Towns of Walpole/Charlestown, NH
Federal No. X-A000(487), NHDOT No. 14747

N.H. Route 12 Reconstruction

**AMENDMENT TO
WATER QUALITY CERTIFICATE APPLICATION**

Subject Amendment to Water Quality Certificate Application
Project Name Walpole-Charlestown 14747
Attention Donald Lyford, P.E., NHDOT Bureau of Highway Design
From John Blackburn, P.E.
Date July 20, 2017
Copies To Samantha Fifield, P.E., NHDOT Bureau of Highway Design

GEOMEMBRANE LINER DAM HEIGHT AT LOW POINTS
NOT TO SCALE

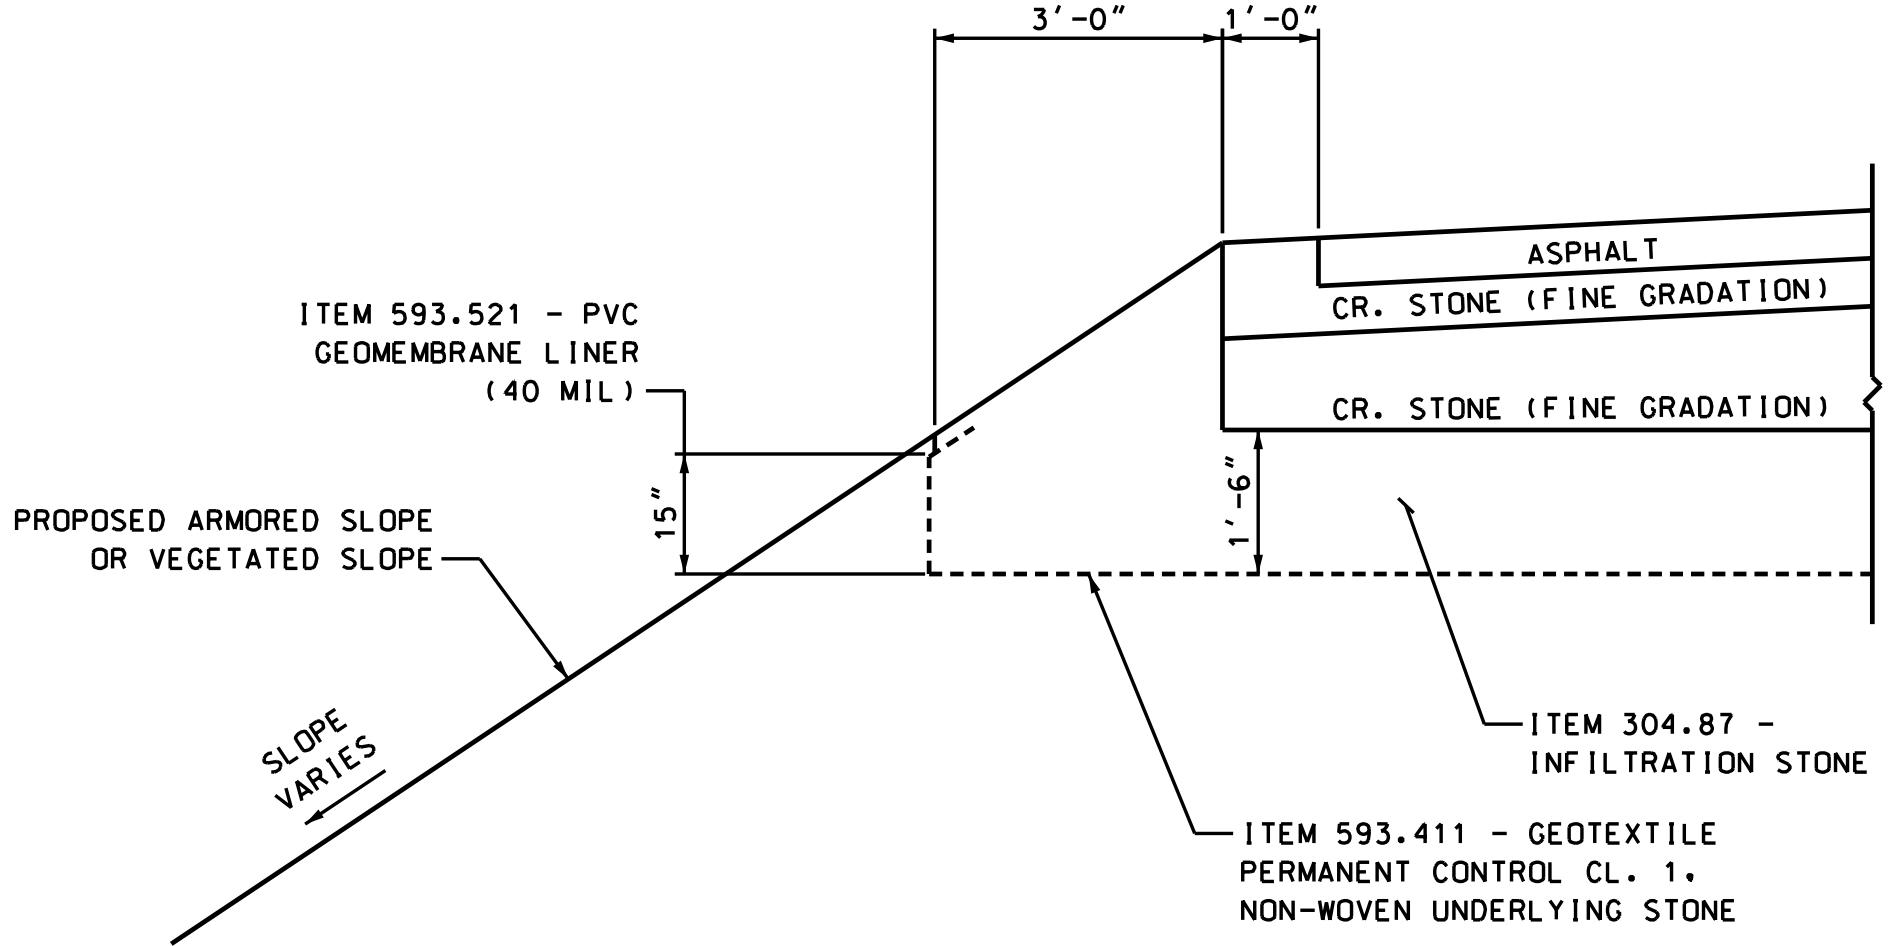
The BMP details were updated to show dams only at the low points. A revised chart on Sheet 16 indicates the necessary height of each dam. The height of the impermeable geomembrane liner along the left side vertical face of the BMP was set to a constant 15 inches, which will ensure the WQV remains contained within all BMPs regardless of dam height.

GEOMEMBRANE LINER DAM HEIGHTS AT LOW POINTS				
TREATMENT AREA	DAM NO.	STATION	DAM HEIGHT	COMMENTS
1A	1	2013+16.5	6"	AT TRANSVERSE DRAINAGE TRENCH 103
1A	2	2013+19.5	6"	AT TRANSVERSE DRAINAGE TRENCH 103
1B	3	2022+53	6"	AT TRANSVERSE DRAINAGE TRENCH B1
2A	4	2025+05	6"	AT TRANSVERSE DRAINAGE TRENCH 112
2B	5	2033+29.5	6"	AT TRANSVERSE DRAINAGE TRENCH 118
2B	6	2033+32.5	10"	AT TRANSVERSE DRAINAGE TRENCH 118
3A	7	2052+98.5	6"	AT TRANSVERSE DRAINAGE TRENCH 131
3A	8	2053+01.5	6"	AT TRANSVERSE DRAINAGE TRENCH 131
3B	9	2061+97	6"	AT TRANSVERSE DRAINAGE TRENCH 135
4A	10	2086+78.5	13"	AT TRANSVERSE DRAINAGE TRENCH B3
4A	11	2086+81.5	6"	AT TRANSVERSE DRAINAGE TRENCH B3
5A	12	2091+63	10"	AT TRANSVERSE DRAINAGE TRENCH B4
5B	13	2103+88.5	6"	AT TRANSVERSE DRAINAGE TRENCH 153
5B	14	2103+91.5	6"	AT TRANSVERSE DRAINAGE TRENCH 153
6A	15	2105+96.5	6"	AT TRANSVERSE DRAINAGE TRENCH B5
6B	16	2114+38.5	8"	AT TRANSVERSE DRAINAGE TRENCH 160

6B	17	2114+41.5	8"	AT TRANSVERSE DRAINAGE TRENCH 160
6C	18	2128+16.5	8"	AT TRANSVERSE DRAINAGE TRENCH 168
6C	19	2128+19.5	6"	AT TRANSVERSE DRAINAGE TRENCH 168
